MIL-A-8591G
AMENDMENT 5
14 August 1987
SUPERSEDING
MIL-A-8591G
AMENDMENT 4
7 May 1987

MILITARY SPECIFICATION

AIRBORNE STORES, SUSPENSION EQUIPMENT AND
AIRCRAFT-STORE INTERFACE (CARRIAGE PHASE);
GENERAL DESIGN CRITERIA FOR

This amendment forms a part of Military Specification MIL-A-8591G, dated 1 December 1983, and is approved for use by all Departments and Agencies of the Department of Defense.

FIGURE 4. Location of store case components, 14-inch lug stores, for carriage on 14-inch lug racks.

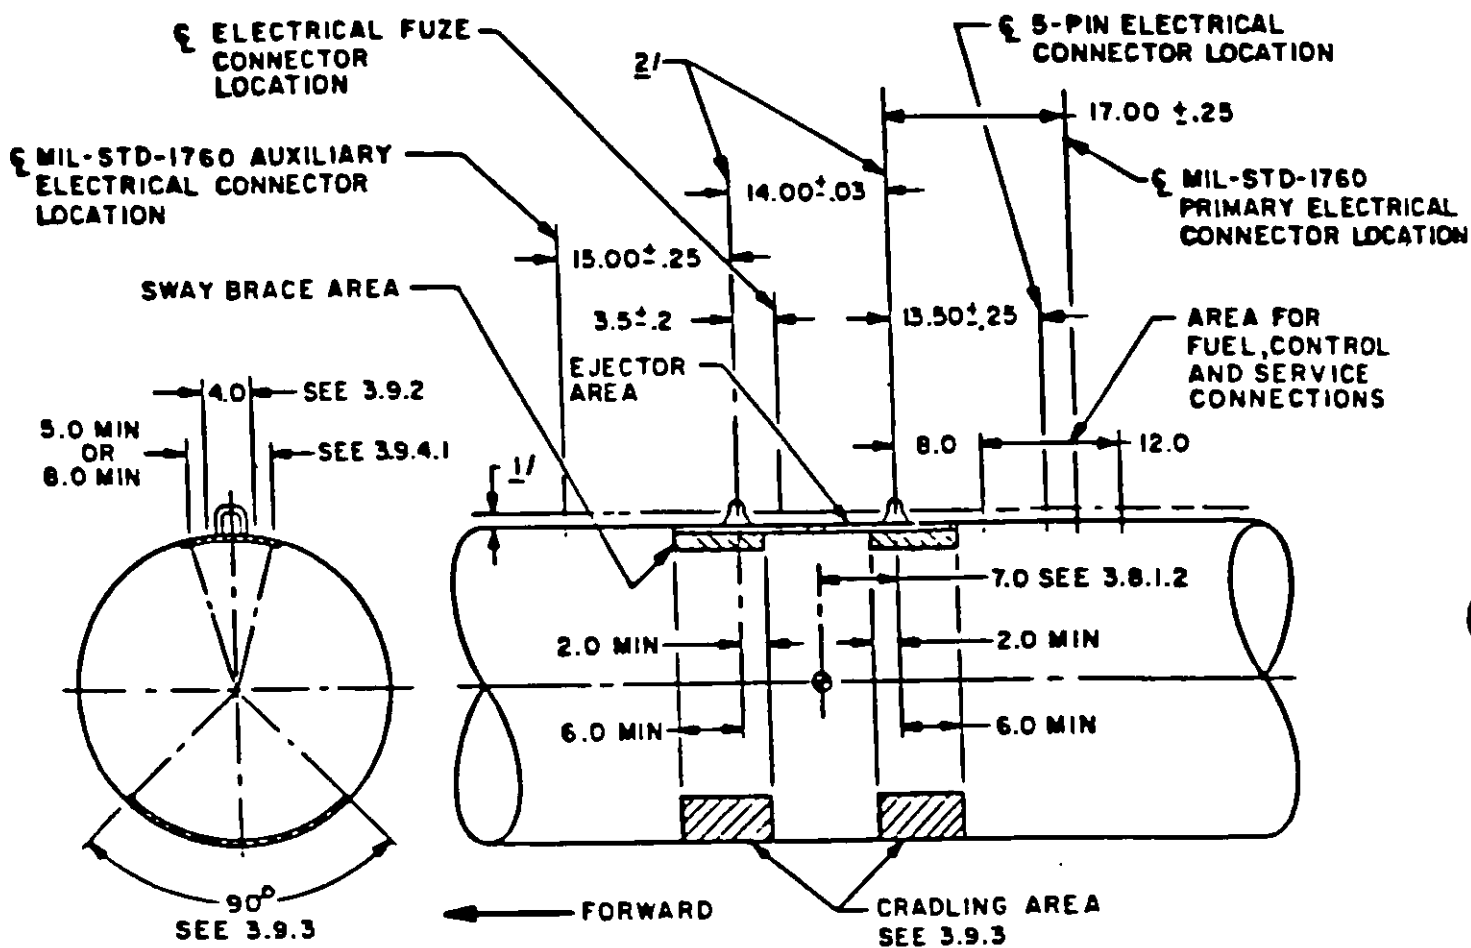
Delete Figure 4 and Notes in their entirety and substitute:

- 1/ A minimum 0.625 inch clearance shall be provided between the rack lower surface and the store upper surface. This clearance shall not apply to rack hooks, braces, ejectors, store lugs or service connections.
- 2/ Lug and lug well axes shall be normal to the store longitudinal axis within $\pm 1/2^\circ$ and in the same plane within $\pm 1/2^\circ$.
3. Dimensions are in inches.

FIGURE 5. Location of store case components, 14-inch lug stores, for carriage on 14 or 30-inch lug racks.

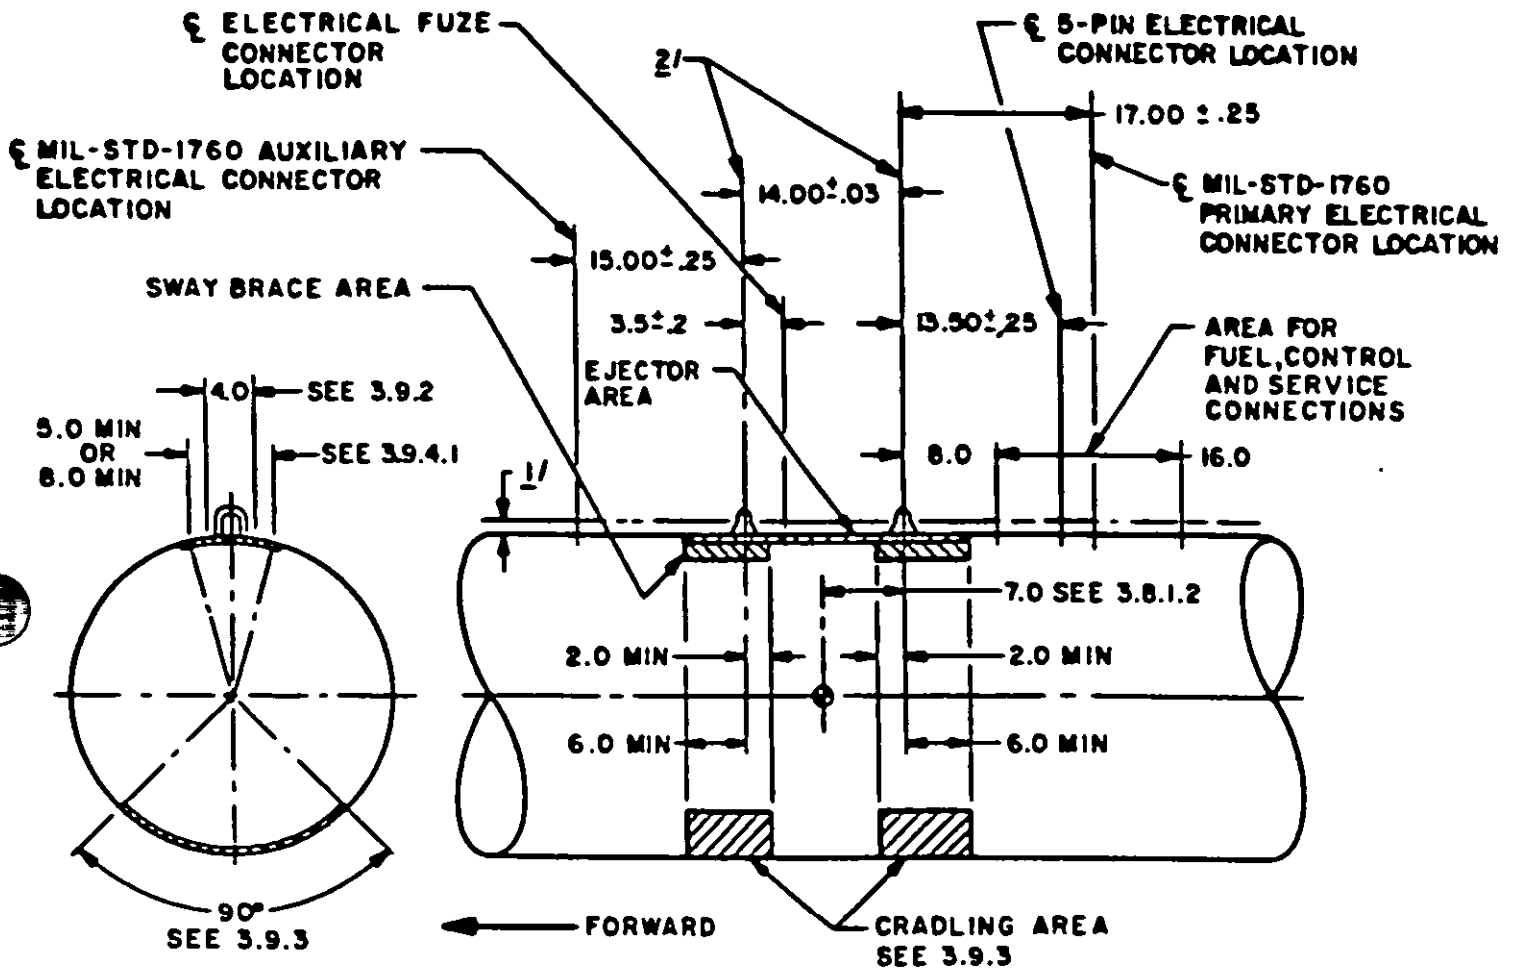
Delete Figure 5 and Notes in their entirety and substitute:

- 1/ A minimum 0.625 inch clearance shall be provided between the rack lower surface and the store upper surface. This clearance shall not apply to rack hooks, braces, ejectors, store lugs or service connections.
- 2/ Lug and lug well axes shall be normal to the store longitudinal axis within $\pm 1/2^\circ$ and in the same plane within $\pm 1/2^\circ$.
3. Dimensions are in inches.

FIGURE 6. Location of store case components, 30-inch lug stores, for carriage on 30-inch lug racks.

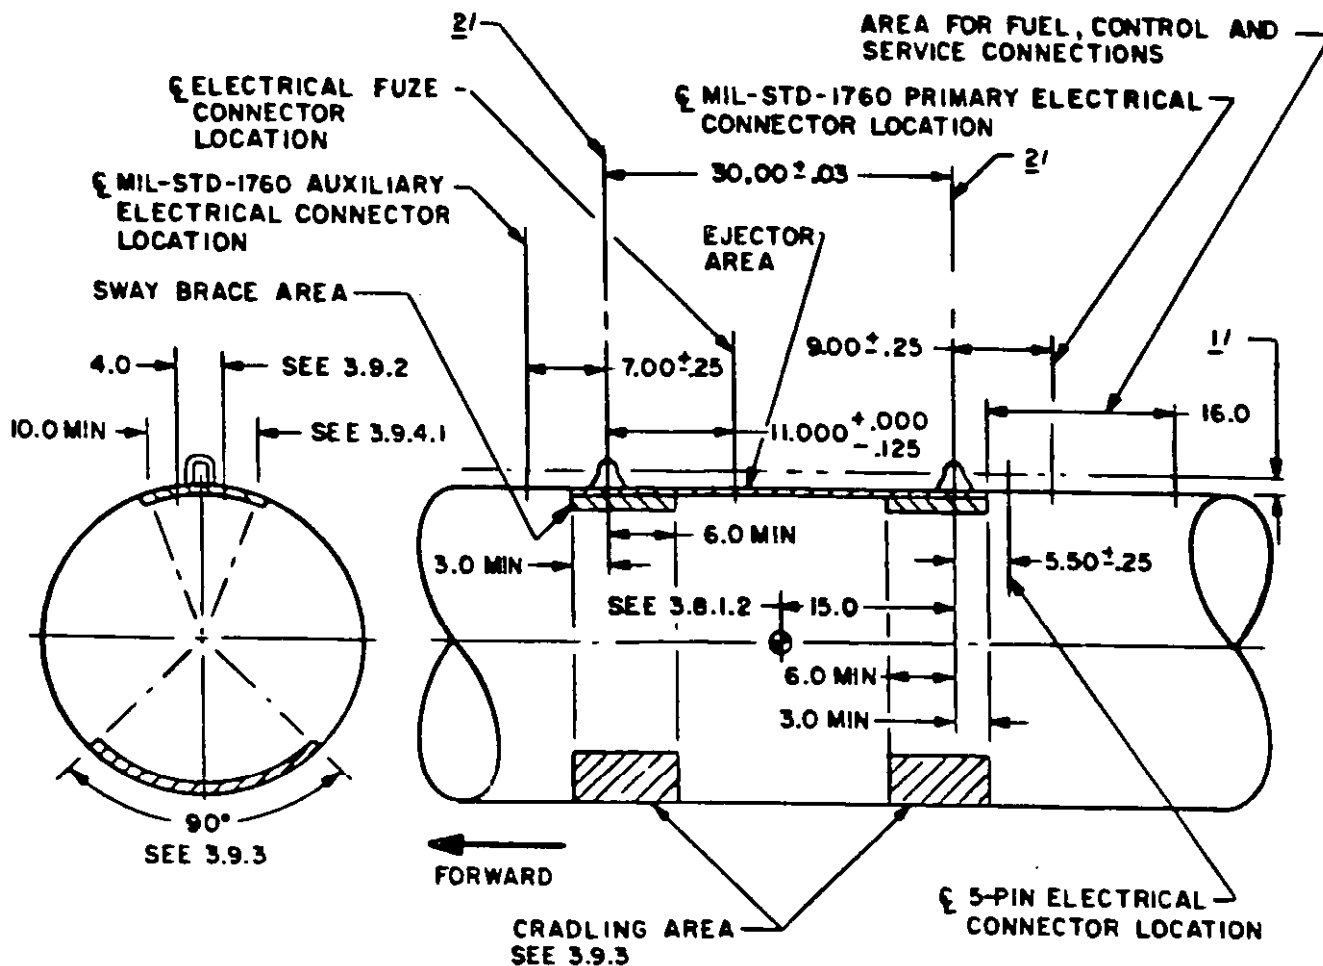
Delete Figure 6 and Notes in their entirety and substitute:

- 1/ A minimum 0.625 inch clearance shall be provided between the rack lower surface and the store upper surface. This clearance shall not apply to rack hooks, braces, ejectors, store lugs or umbilical connections.
- 2/ Lug and lug well axes shall be normal to the store longitudinal axis within $\pm 1/2^\circ$ and in the same plane within $\pm 1/2^\circ$.
3. Dimensions are in inches.
